October 10, 2023

Kittson-Roseau Joint Ditch Board
407 5th Ave NW
Roseau, MN 56751

**Subject: Engineer's Report and Findings of Fact
State Ditches No. 95 and 72
HEI Project No. 6263_0033**

FIGURE 1 - KLONDIKE CLEAN WATER RETENTION PROJECT FEATURES (SOURCE: HDR)

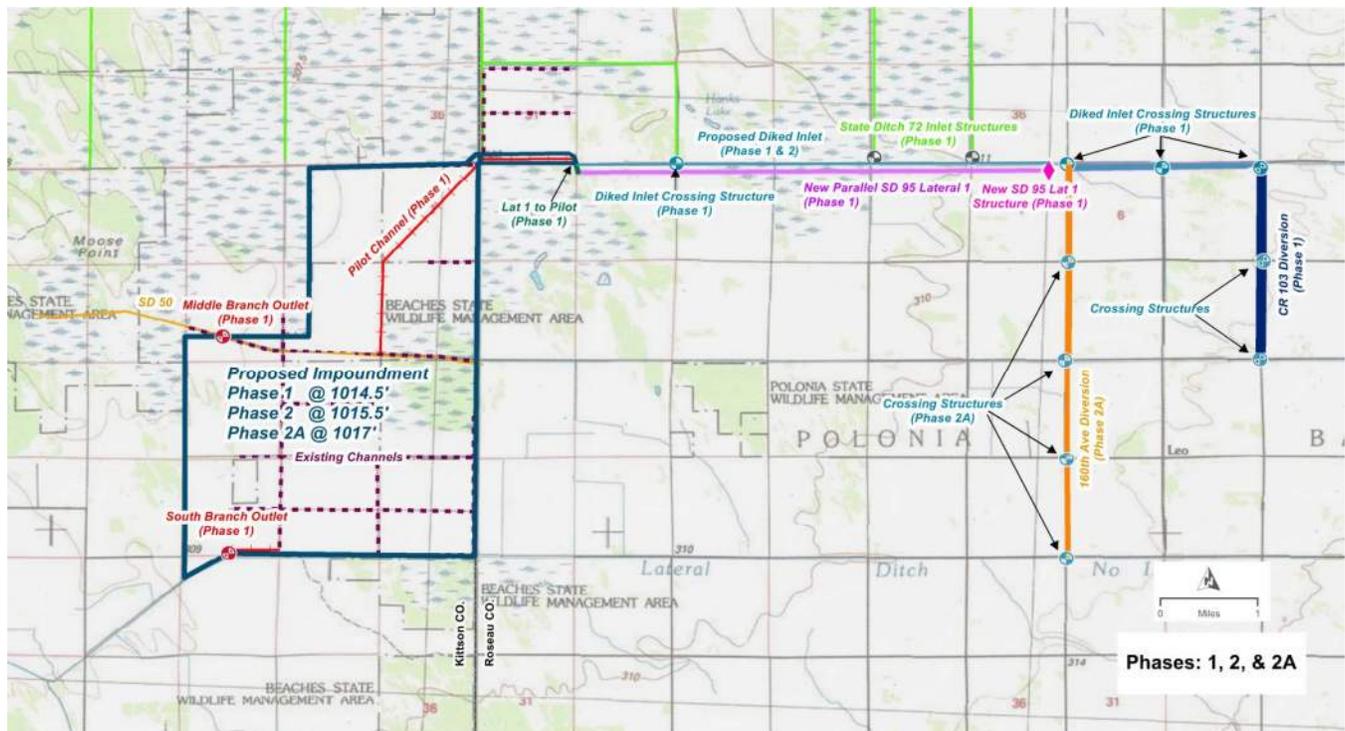
Depending upon funding, the project may be constructed in 3 phases. Phase 1 will store up to 16,500 acre-feet of water, phase 2 up to 26,750 acre-feet, and phase 3 up to 35,250 acre-feet. In summary, the project includes multiple features as shown on Figure 1. Project features labeled as Phase 1 and 2 are the currently proposed alternative. Phase 2A is beyond the scope of the current project. The review discussed in this report considers the implementation of Phase 1 and 2 features as shown on Figure 1.

FIGURE 3: TYPICAL ROAD SECTIONS ALONG DIKED INLET (SOURCE: HDR)

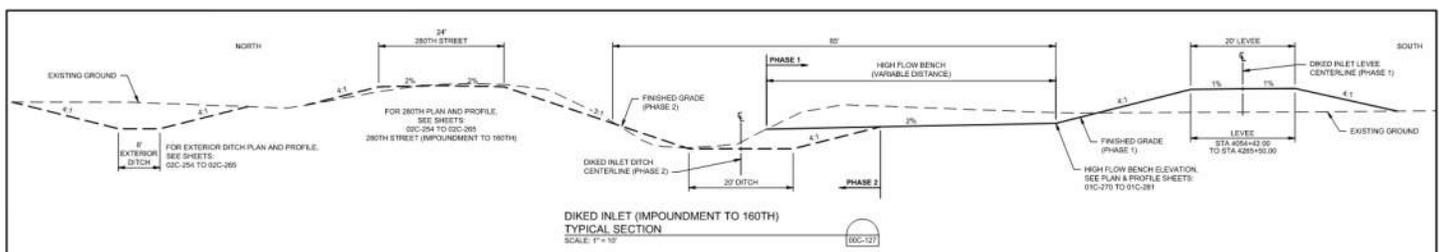
Along the diked inlet, a minimum maintenance road is proposed on the south side of the diked inlet along the south line of Sections 31 of Juneberry Township, the northeast corner of Section 6 of Polonia Township, and along the north side of Sections 1, 2, 3, 4, and 5 of Polonia Township. 280th ST will be built as a minimum maintenance road in Sections 31 and 32 of Juneberry Township with a 20-foot top width. Further east in Sections 33, 34, 35, and 36 of Juneberry Township, 280th ST will be rebuilt with a 24-foot top width. Here slopes will be 4H:1V on the north side of the road and 3H:1V on the south side of the road as shown in the figure below.

A new improved 280th ST north road ditch will be constructed which should improve road drainage along 280th ST. These road modifications would generally be improvements over the roads that currently exist in the project area today. In general, the existing roads are narrower with steeper sideslopes than what is being proposed. The proposed roads would meet the current design standards for roads of this classification and average daily traffic.

Along the Diked inlet there is one area on 120th Ave that has an overflow section. While this area is reinforced with riprap, this area will need to be reviewed after significant runoff events to ensure the road is maintained.

While the design plans provided are preliminary, signage should be provided in future plans that address safety for the traveling public so that they are aware of the changes that are proposed. An example would be a "Road May Flood" sign for the low water crossing. Speed warning may also be

Lat 6 - Huseby Hydrograph

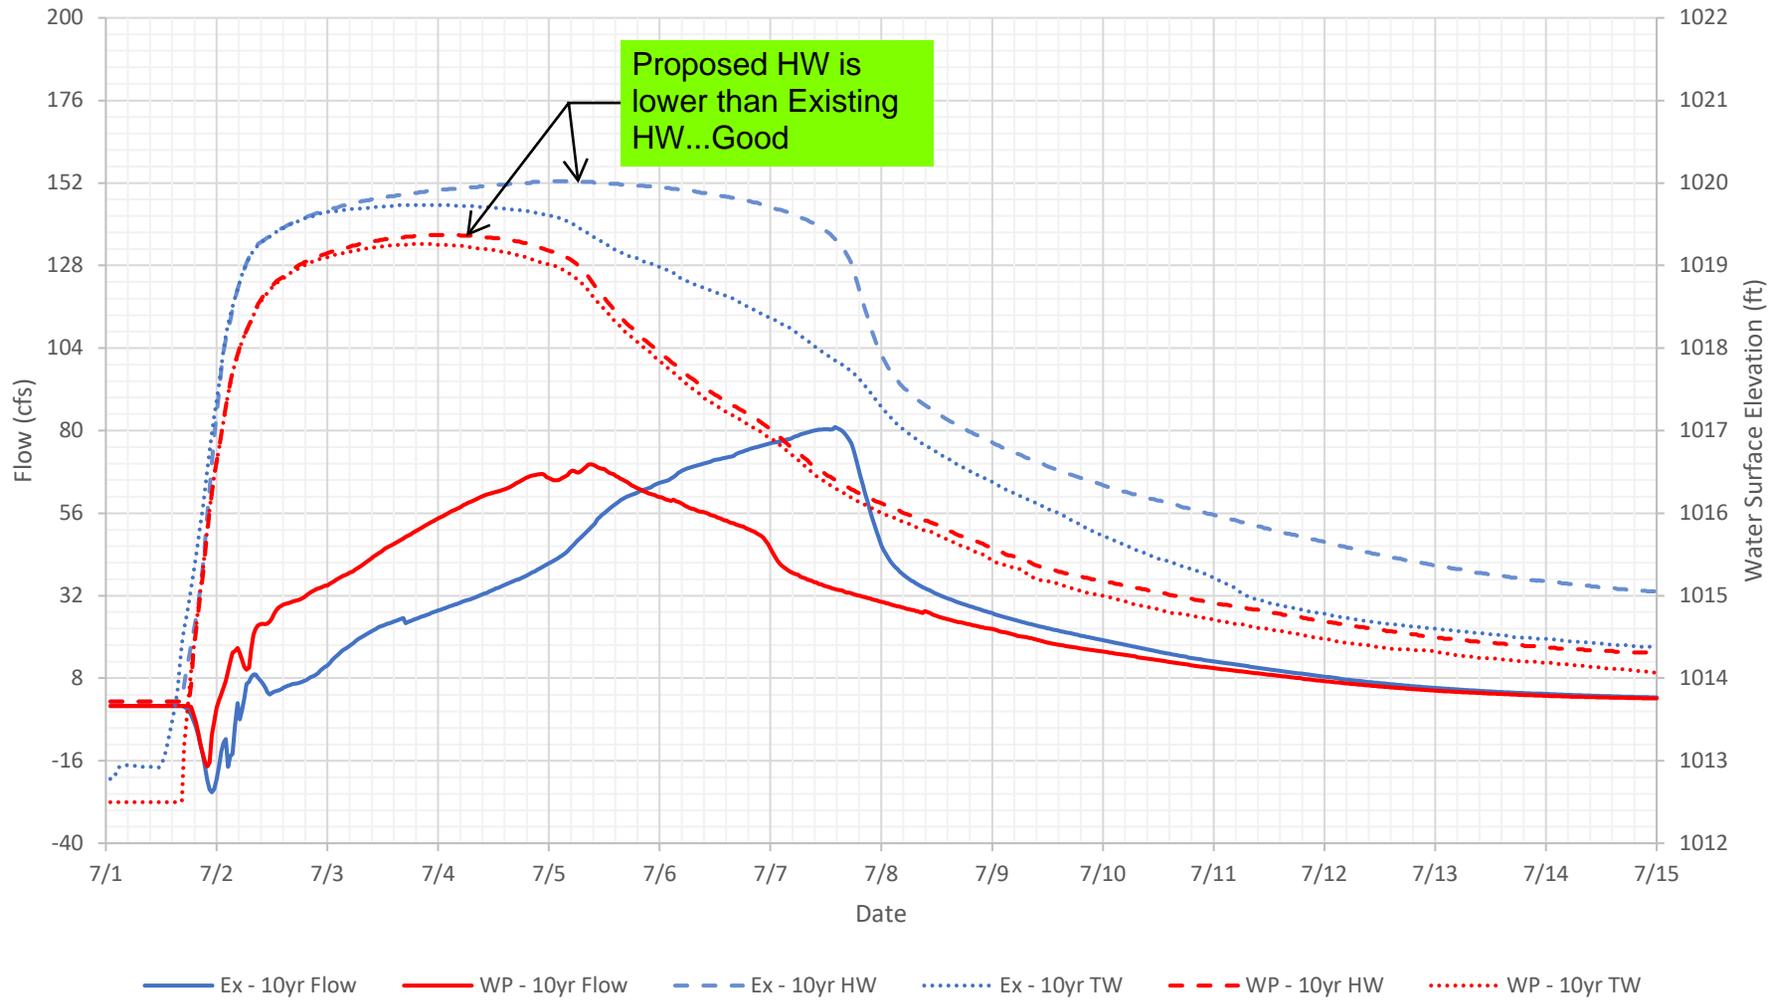
Proposed HW is lower than Existing HW...Good

Lat 8 - Wang Hydrograph

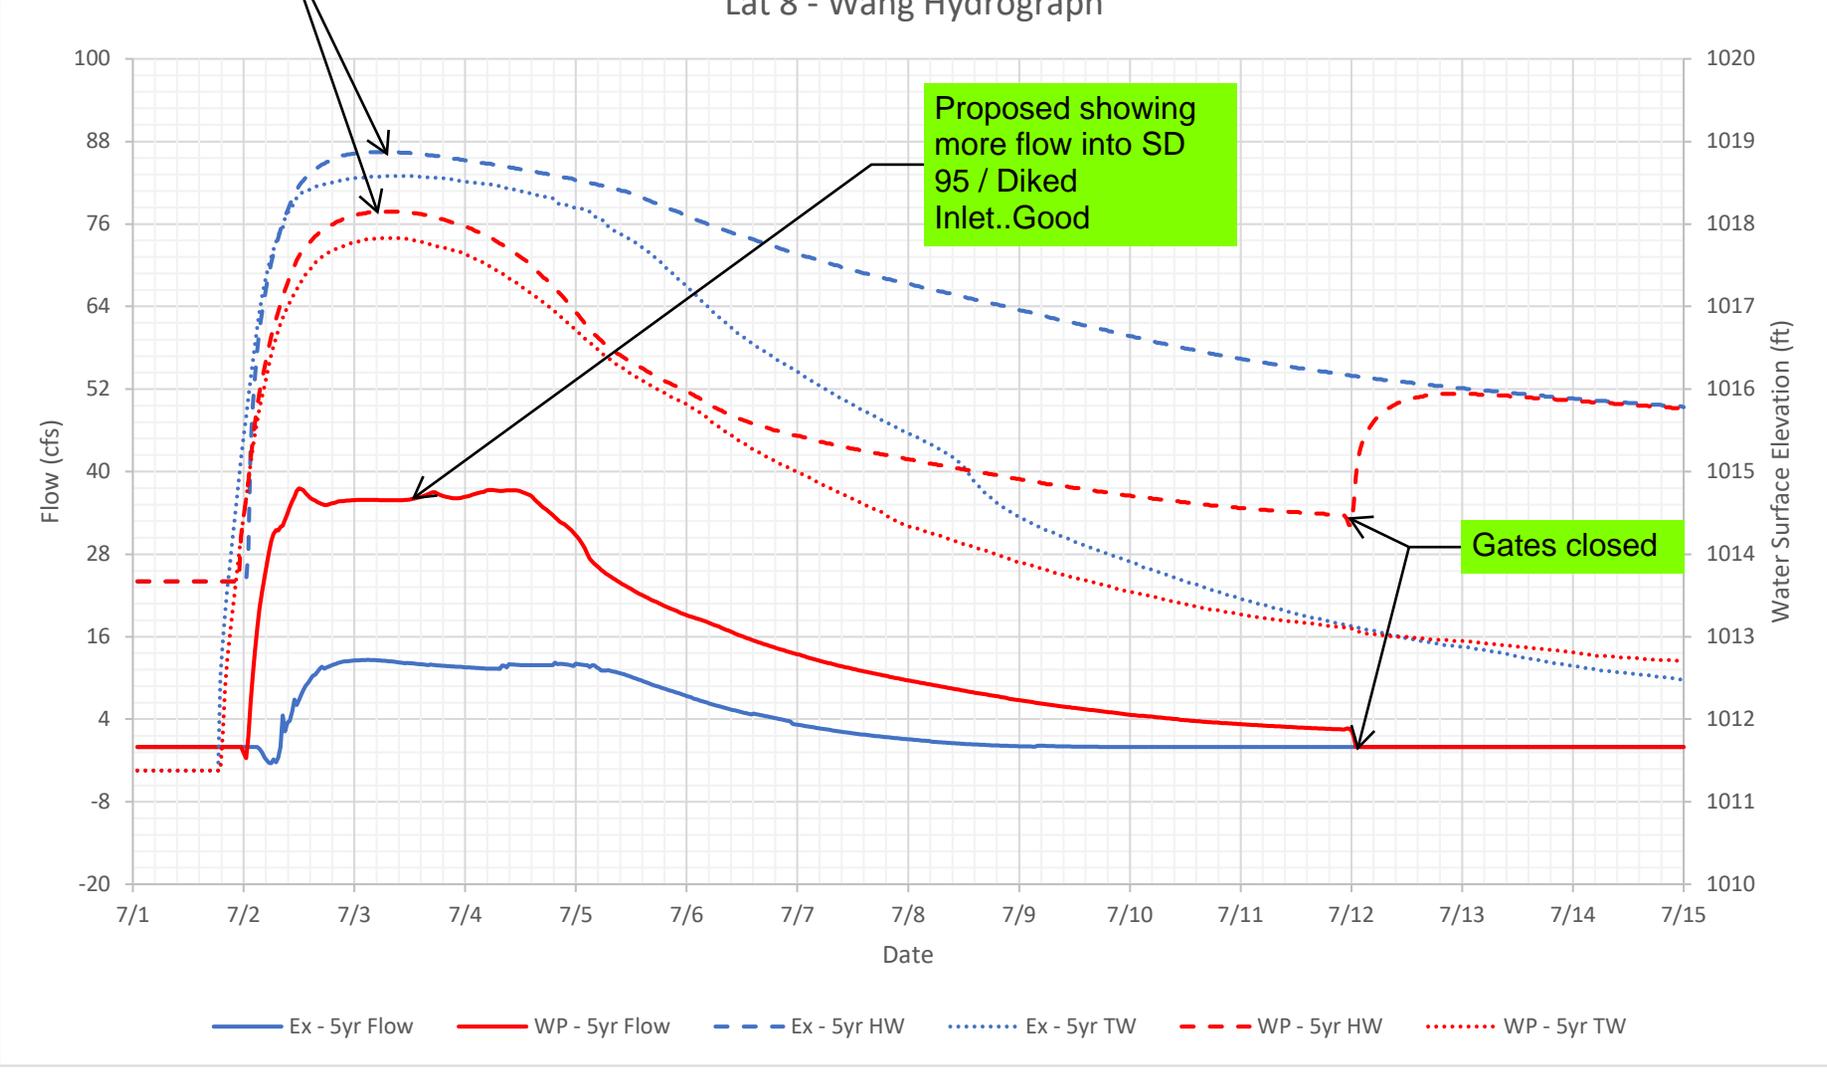
Proposed showing more flow into SD 95 / Diked Inlet..Good

Proposed HW is lower than Existing HW...Good

Lat 8 - Wang Hydrograph

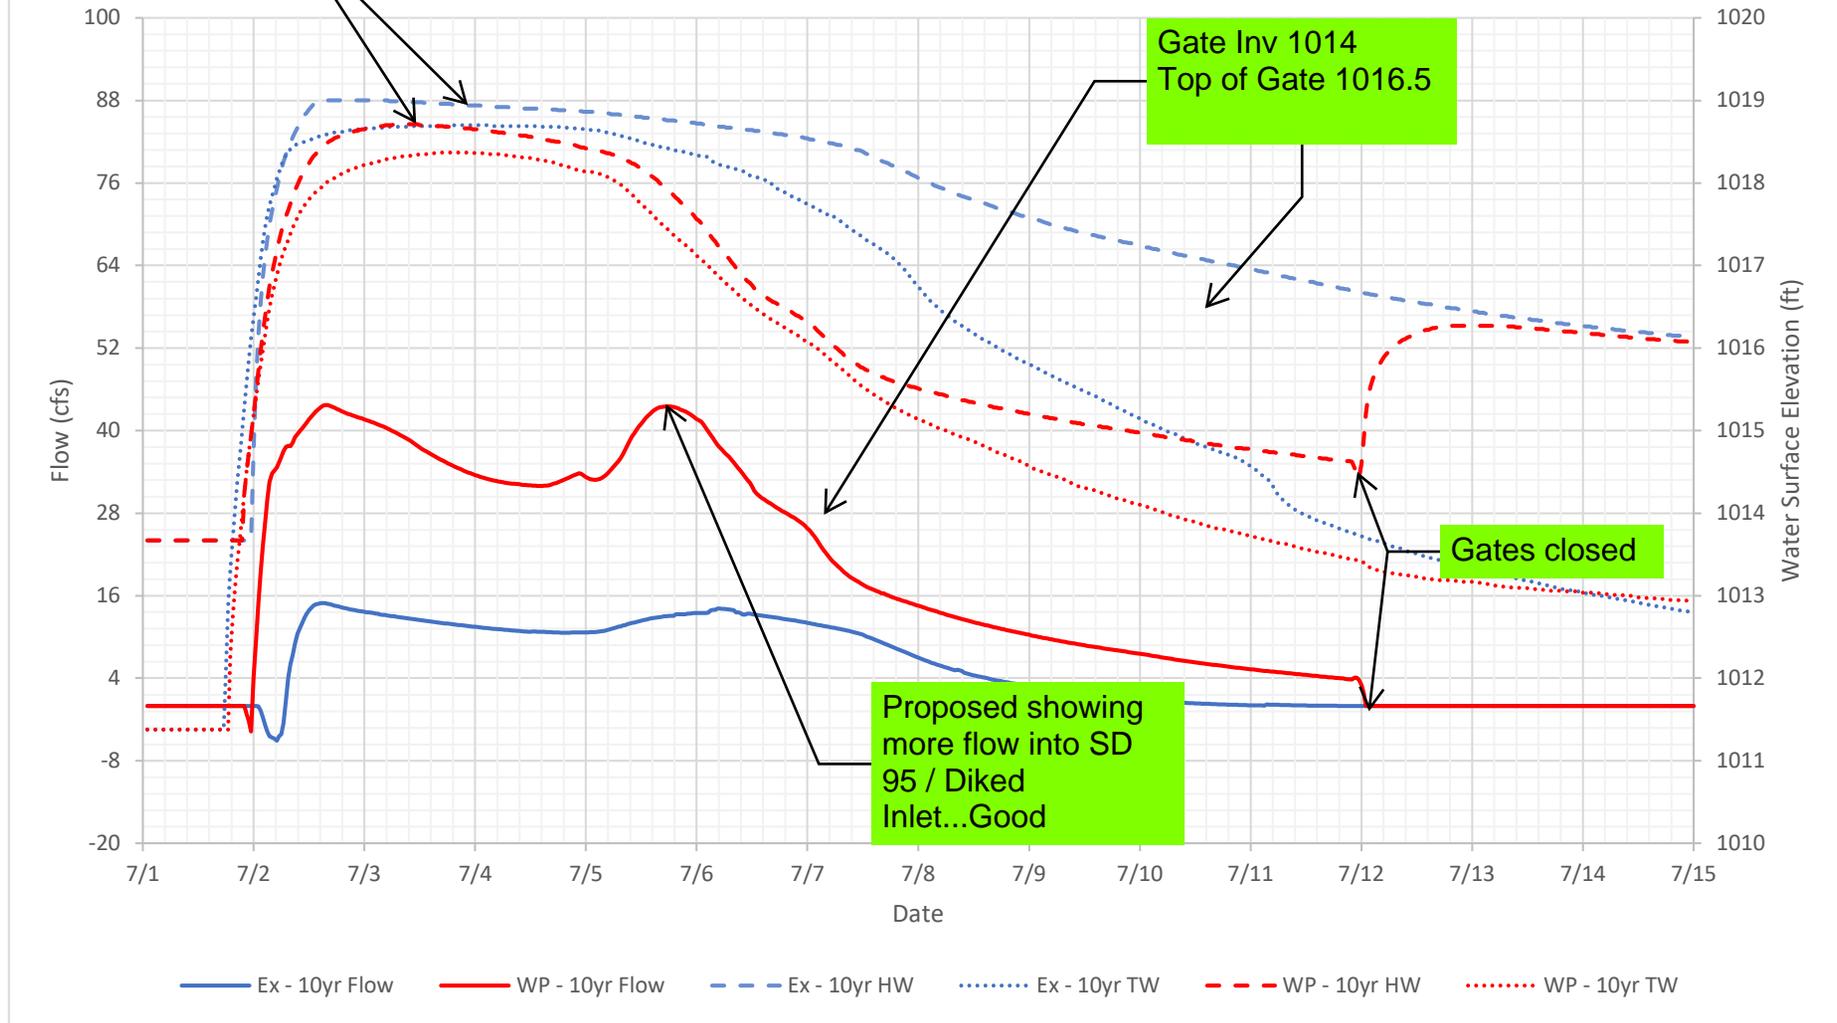
Proposed showing more flow into SD 95 / Diked Inlet...Good
